THE PORT AUTHORITY OF NY & NJ

ADDENDUM #5

TO PROSPECTIVE BIDDER(S) ON **BID # MCP-254.254 (RFx 7*453) – (FTA) – Port Authority Bus Terminal – Midtown Bus Terminal Replacement Program – Dyer Deck-Overs**

The following changes/modifications are hereby made to the solicitation documents:

Designed by	L.SEVERINOVS
Drawn by	K.KOSLIK
Checked by	S.DELUCIA
Date	01/23/2024
Contract Number	MCP-254.254
Drawing Number	DD-E0100
PID#	18982000

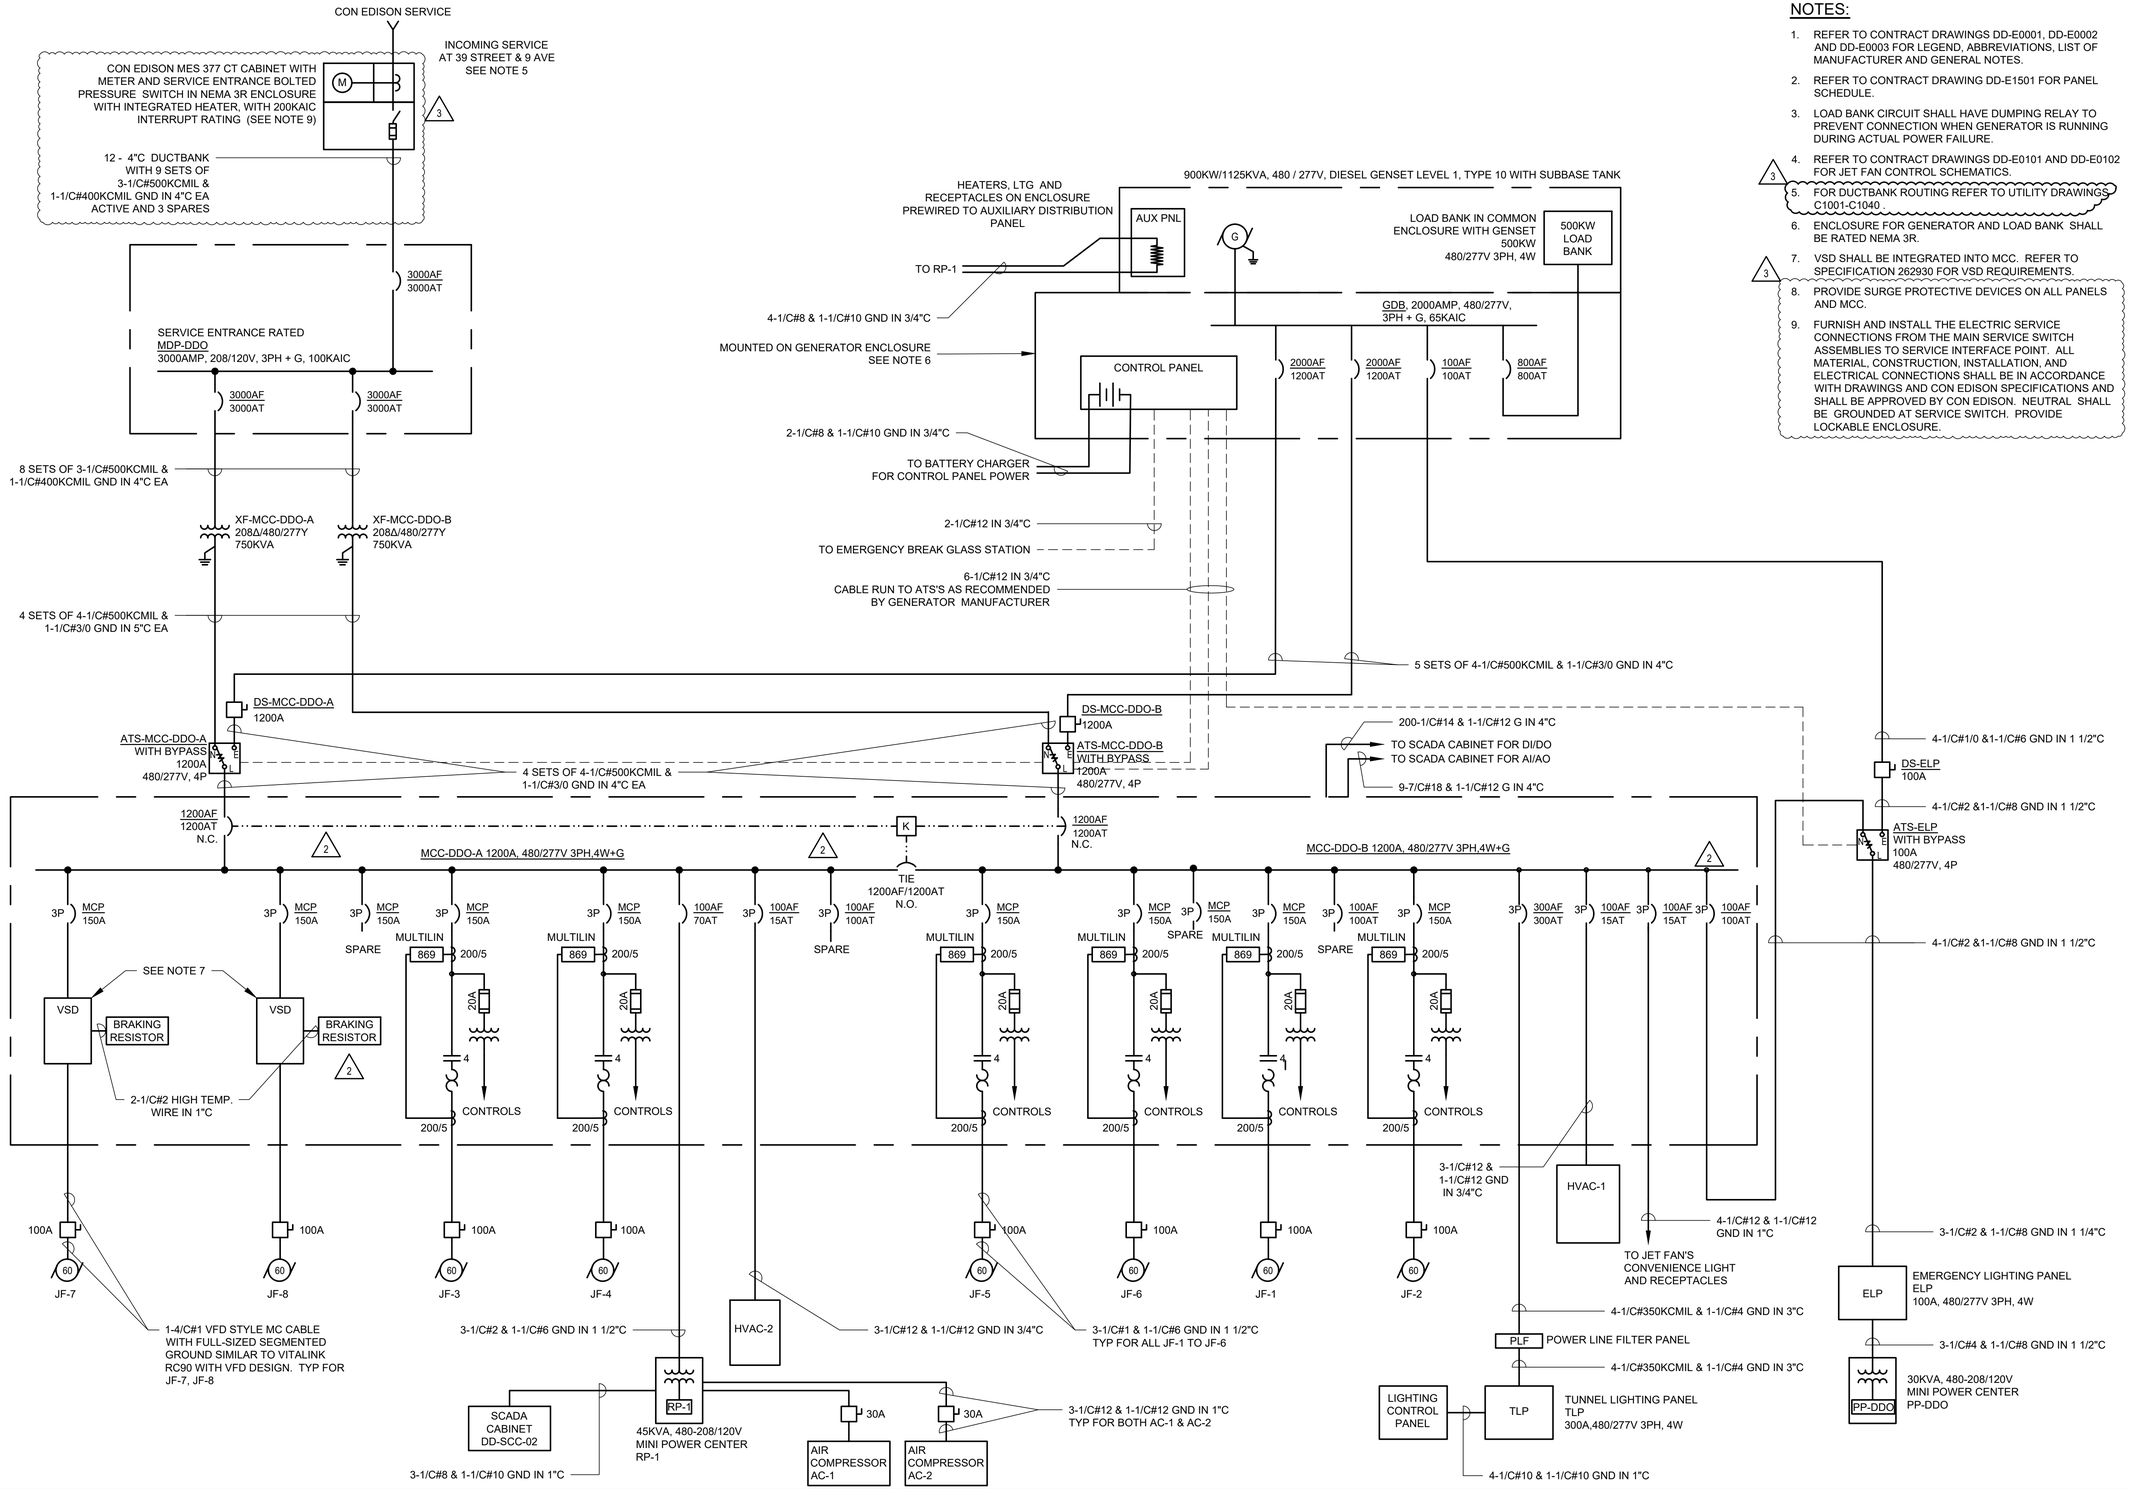
Question #65	On drawing DD-E0100 – please indicate the size of the pipe and wire for the Con-Ed Service, also please locate this service on the utility drawings to quantify.

Answer #65	Revised drawing issued with this addendum.
Question #66	We request that the PANYNJ inform the stated sole source providers of this project and grant them access to the documents in order for them to supply pricing.
